RENESAS TECHNICAL UPDATE

Product Category	MPU/MCU		Document No.	TN-RX*-A099A/E	Rev.	1.00
Title	Changes to description of Complementary PWM Mode of MTU2/MTU2a/MTU3		Information Category	Technical Notification		
Applicable Product	RX62N Group, RX621 Group, RX62T Group, RX62G Group, RX630 Group, RX63T Group, RX63N Group, RX631 Group, RX210 Group, RX21A Group, RX220 Group RX111 Group	Lot No.	Reference Document	User's Manual: Hardware for applicable products (see the table at the bottom)		
		All lots

This document describes changes to description of Complementary PWM Mode of MTU2/MTU2a/MTU3.

Figure 22.46 Example of Waveform Output in Complementary PWM Mode (1)

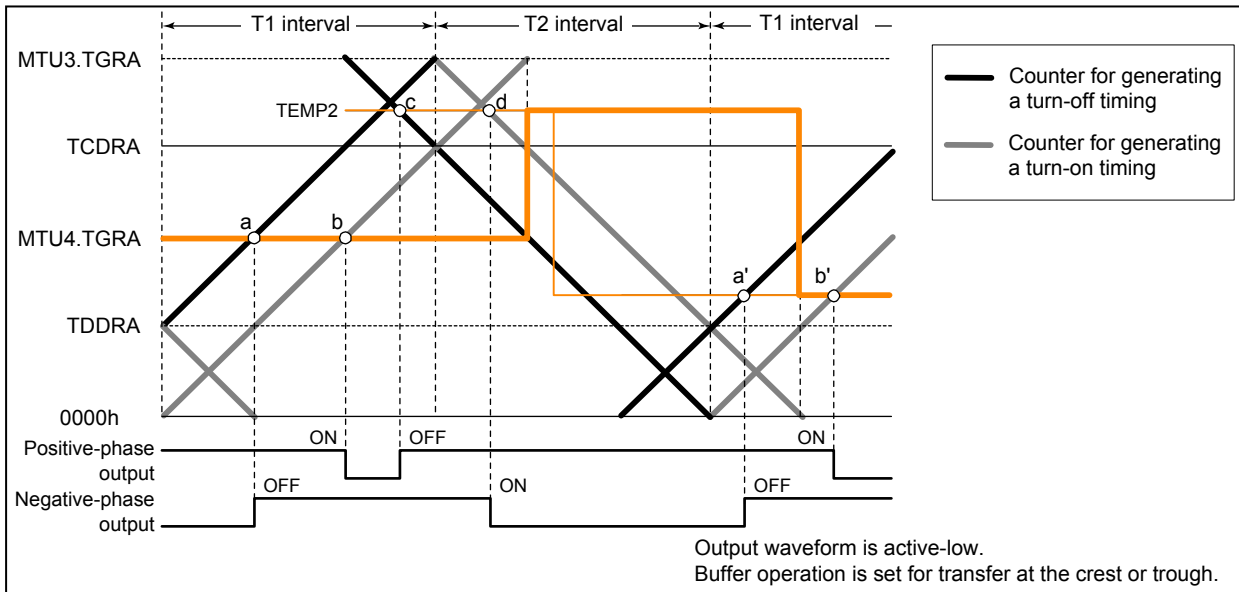
Correct a 'Figure 22.46 Example of Waveform Output in Complementary PWM Mode (1)'.

Figure 22.47 Example of Waveform Output in Complementary PWM Mode (2)

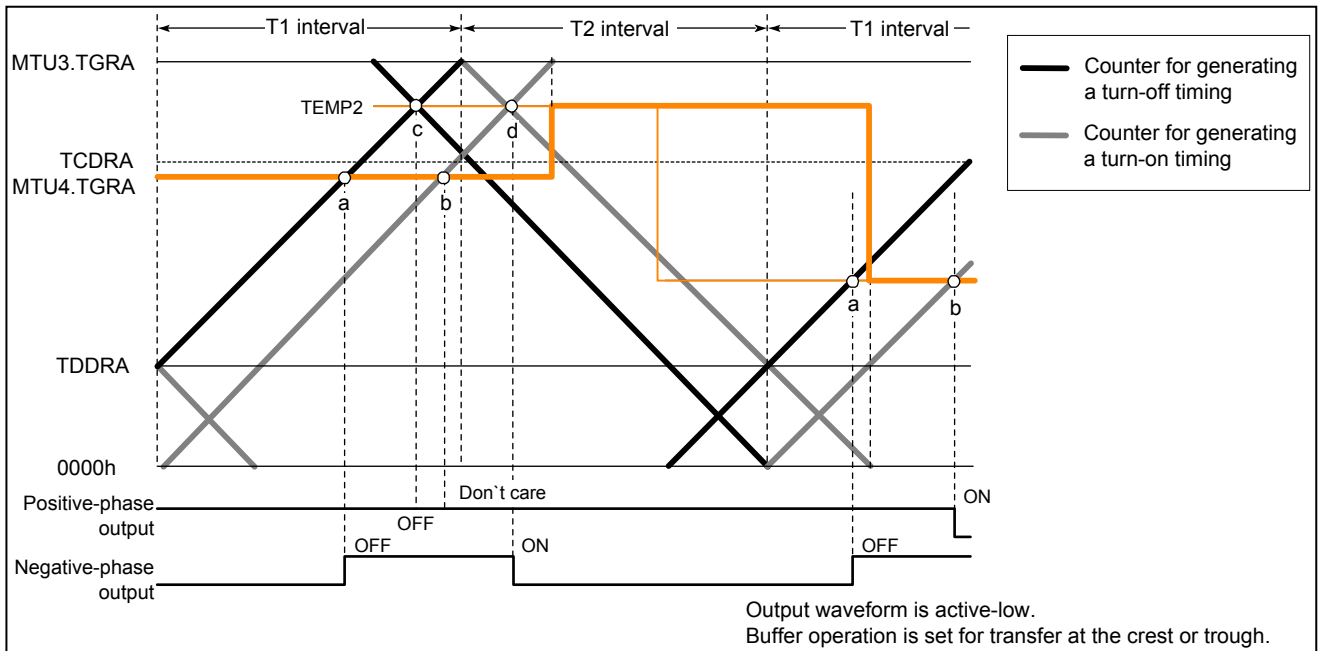
Correct a 'Figure 22.47 Example of Waveform Output in Complementary PWM Mode (2)'.

Figure 22.48 Example of Waveform Output in Complementary PWM Mode (3)

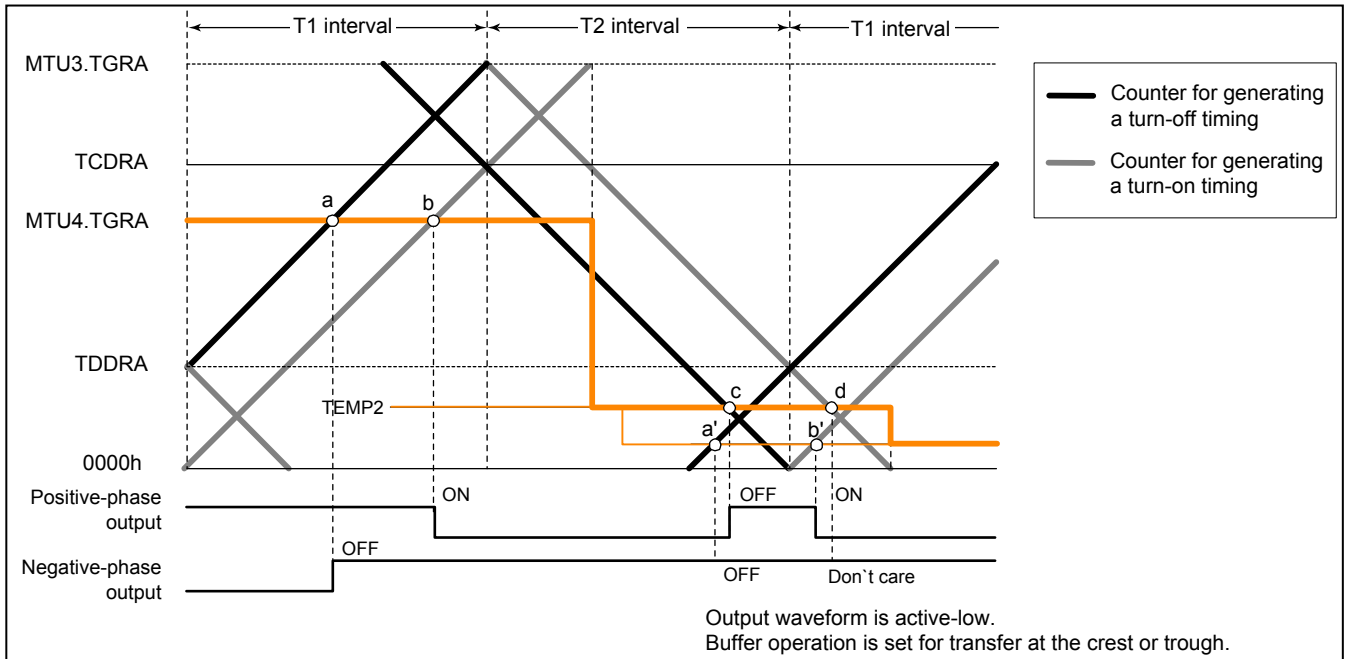
Similarly, in the example in Figure 22.48, compare match a' with new data in the temporary register occurs before compare match c, but until compare match c, which turns off the positive phase, other compare matches are ignored. As a result, the negative phase is not turned on.

Correct a 'Figure 22.48 Example of Waveform Output in Complementary PWM Mode (3)'.
 Correct a 'Figure 22.49 Example of 0% and 100% Waveform Output in Complementary PWM Mode (1)'.

Similarly, in the example in Figure 22.48, turning off the negative phase has priority due to the occurrence of compare match a' (negative-phase off timing) before compare match d (negative-phase on timing). As a result, the negative phase is not turned on.

Figure 22.49 Example of 0% and 100% Waveform Output in Complementary PWM Mode (1)

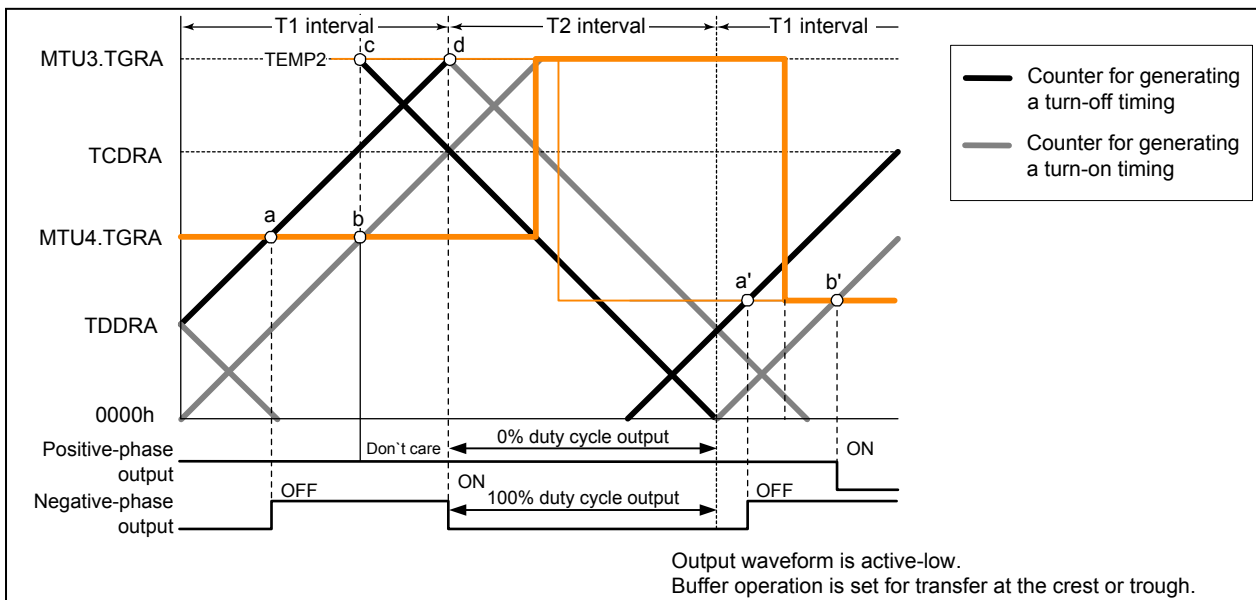
Correct a 'Figure 22.49 Example of 0% and 100% Waveform Output in Complementary PWM Mode (1)'.

Figure 22.50 Example of 0% and 100% Waveform Output in Complementary PWM Mode (2)

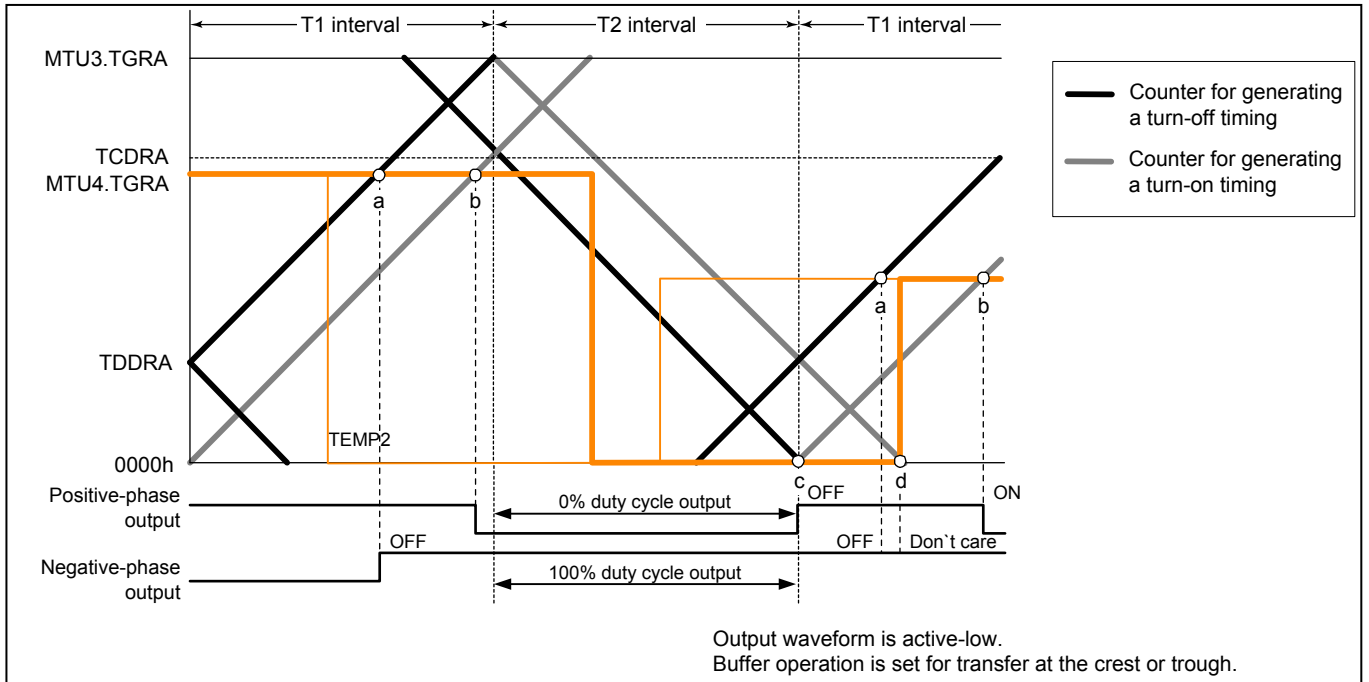
Correct a 'Figure 22.50 Example of 0% and 100% Waveform Output in Complementary PWM Mode (2)'.
 Correct a 'Figure 22.51 Example of 0% and 100% Waveform Output in Complementary PWM Mode (3)'.

Figure 22.51 Example of 0% and 100% Waveform Output in Complementary PWM Mode (3)

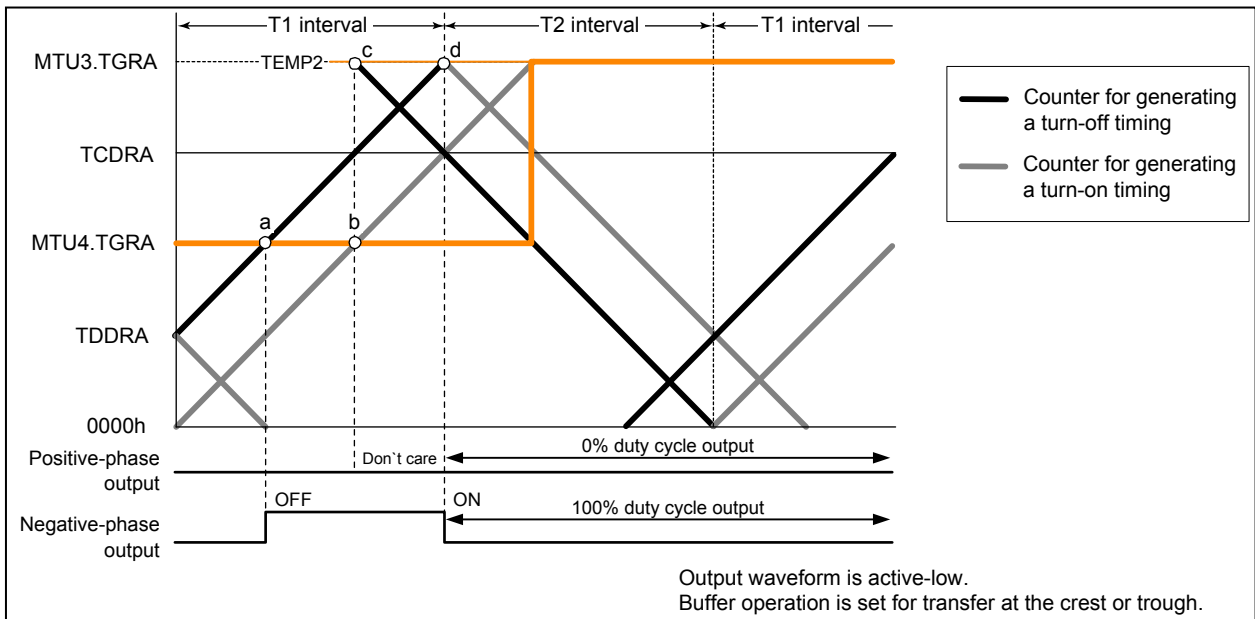
Correct a 'Figure 22.51 Example of 0% and 100% Waveform Output in Complementary PWM Mode (3)'.

Figure 22.52 Example of 0% and 100% Waveform Output in Complementary PWM Mode (4)

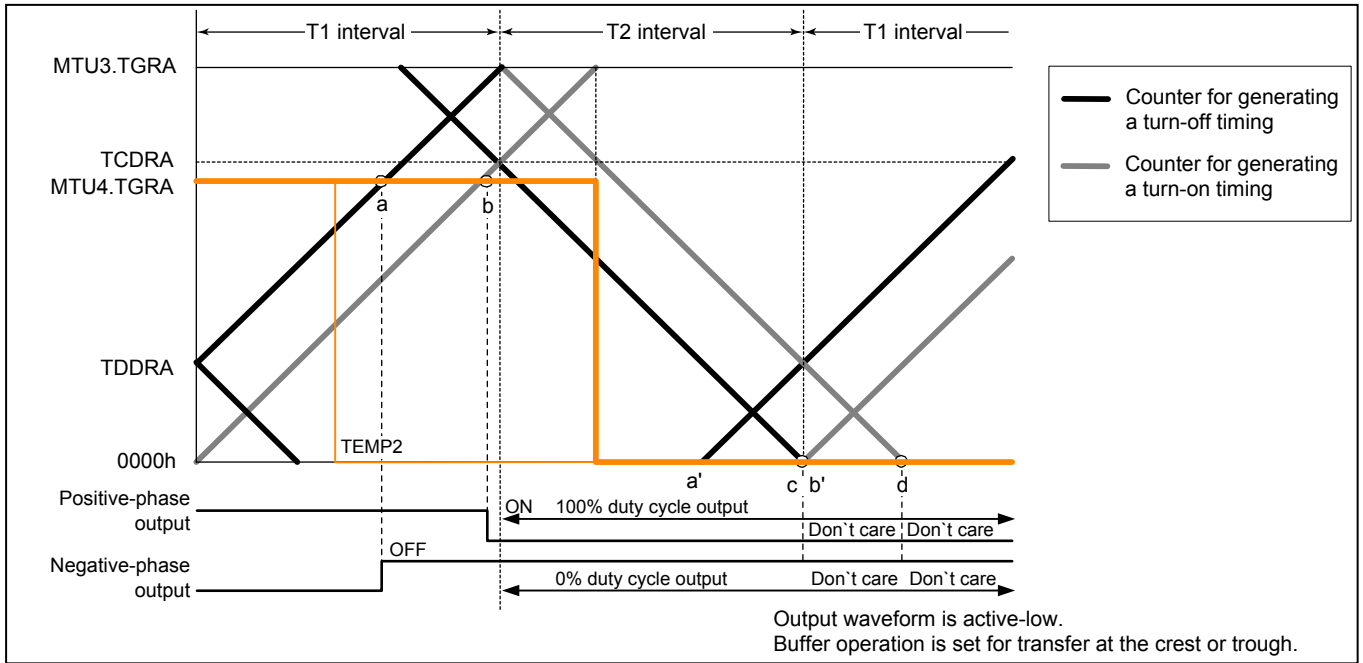
Correct a 'Figure 22.52 Example of 0% and 100% Waveform Output in Complementary PWM Mode (4)'.
'

Figure 22.53 Example of 0% and 100% Waveform Output in Complementary PWM Mode (5)

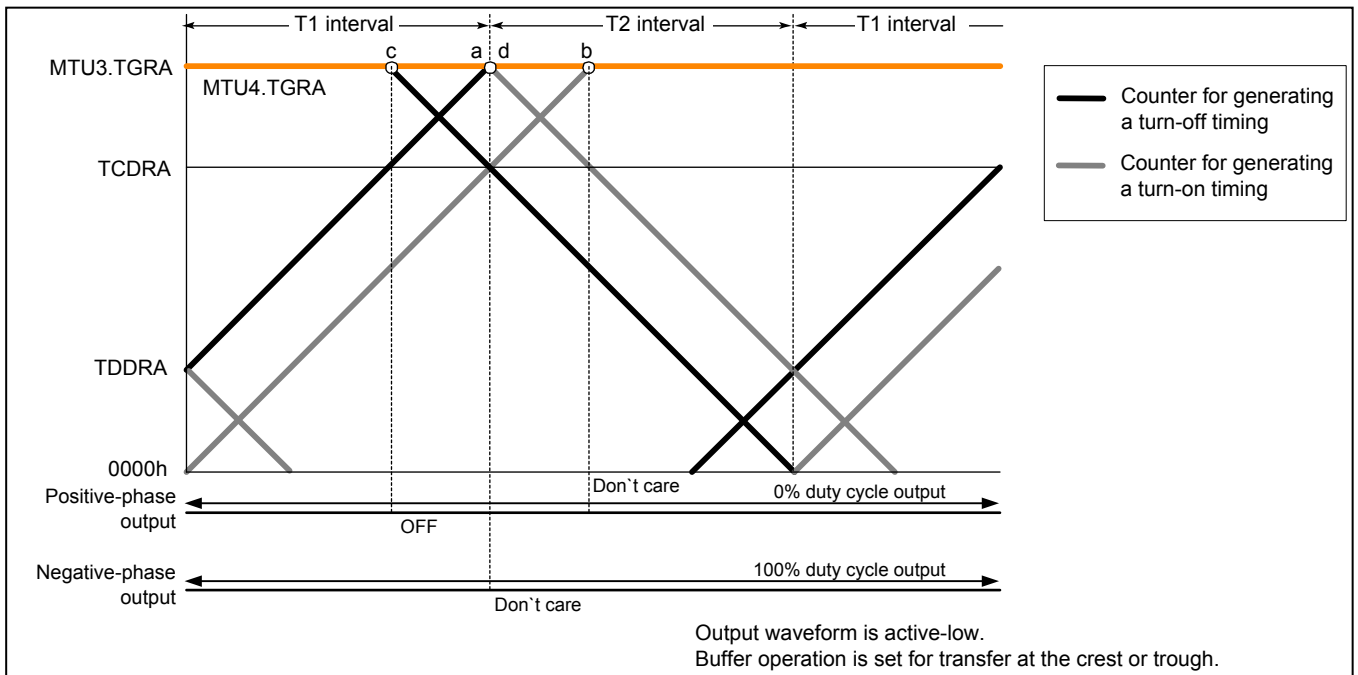
Correct a 'Figure 22.53 Example of 0% and 100% Waveform Output in Complementary PWM Mode (5)'.
'

Figure 22.71 Example of Operation when Buffer Transfer is Linked with Interrupt Skipping (BTE[1:0] = 10b)

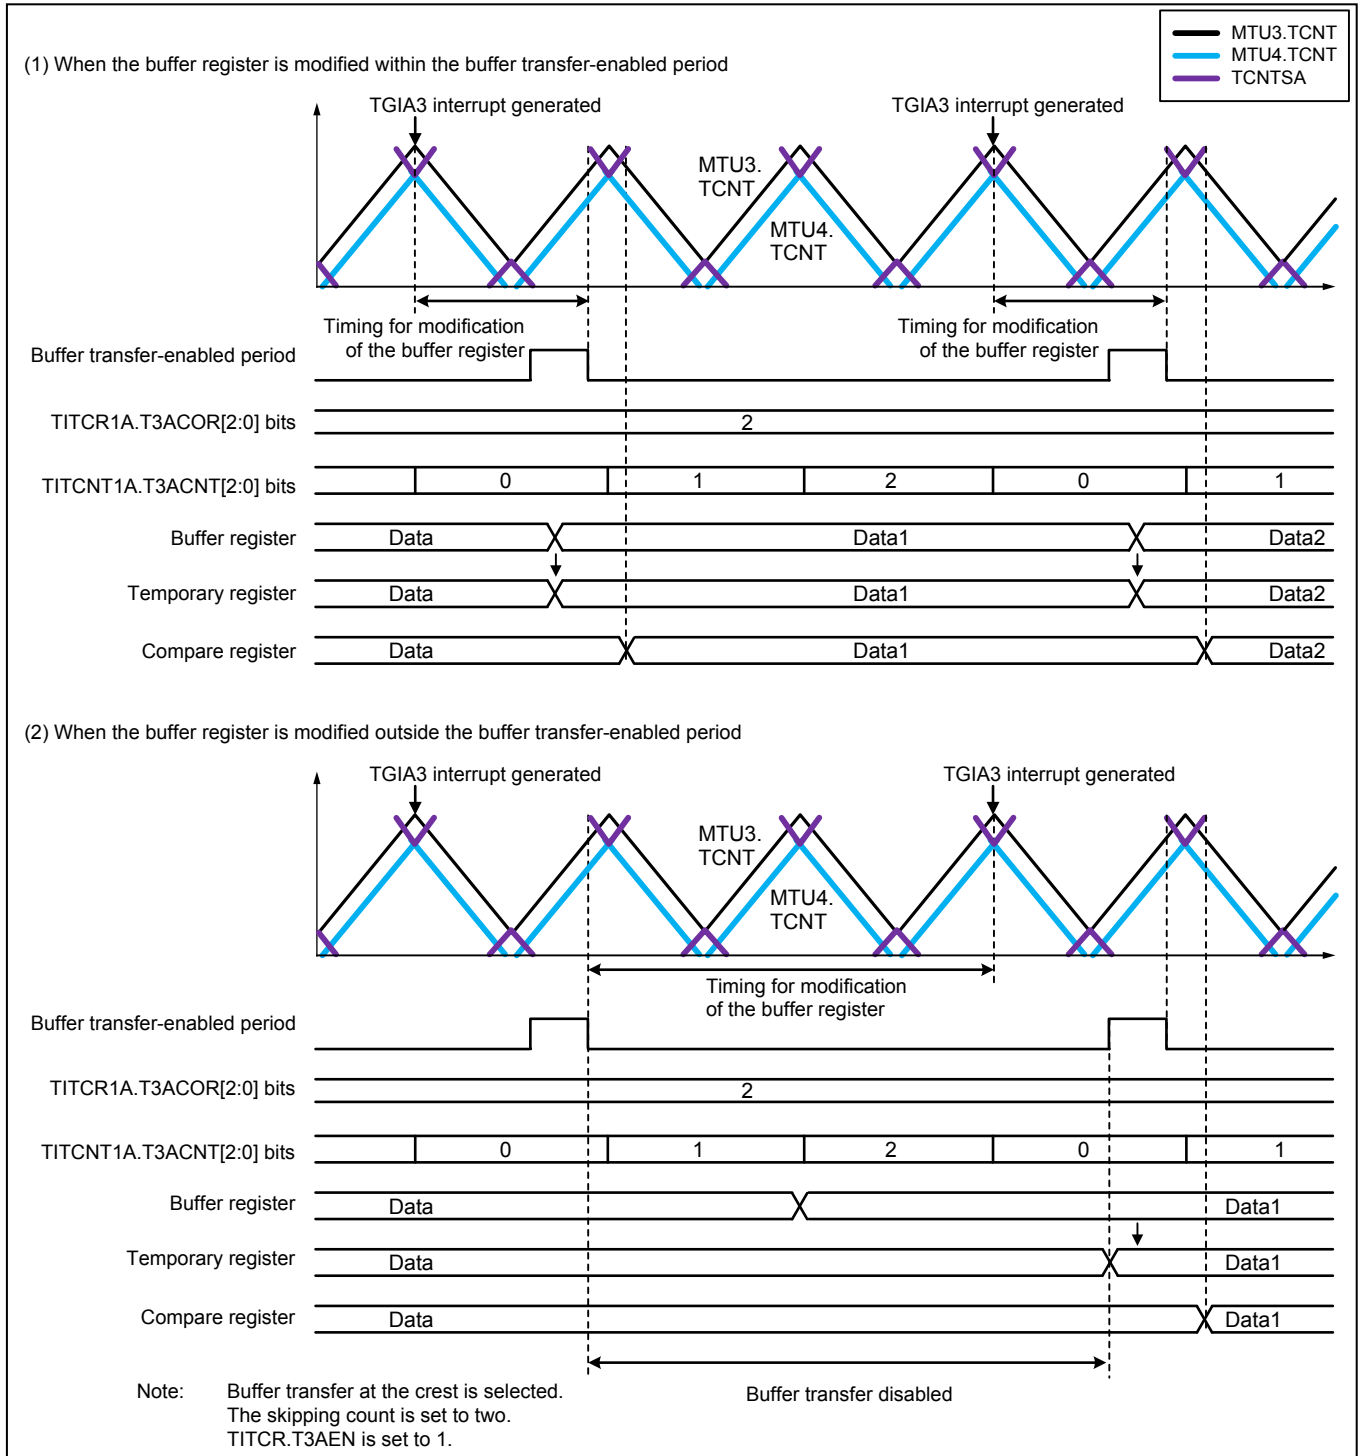
Correct a 'Figure 22.71 Example of Operation when Buffer Transfer is Linked with Interrupt Skipping (BTE[1:0] = 10b)'.

Figure 22.72 Relationship between Bits T3AEN and T4VEN in TITCR and Buffer Transfer-Enabled Period

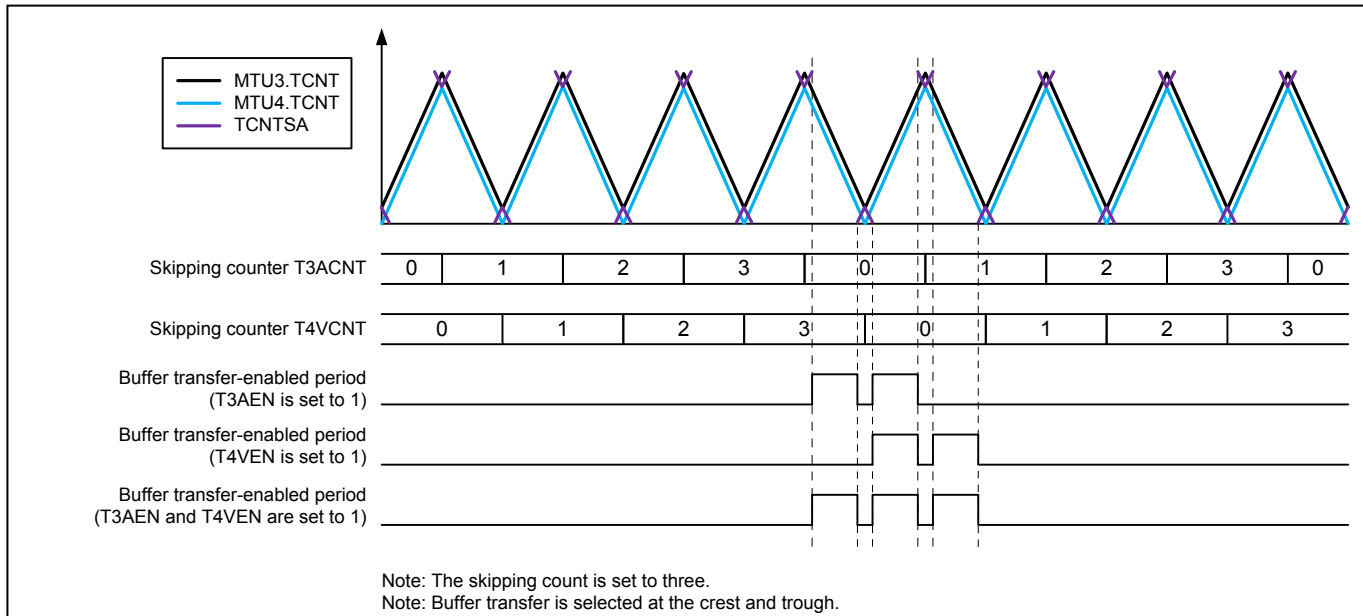
Correct a 'Figure 22.72 Relationship between Bits T3AEN and T4VEN in TITCR and Buffer Transfer-Enabled Period'.
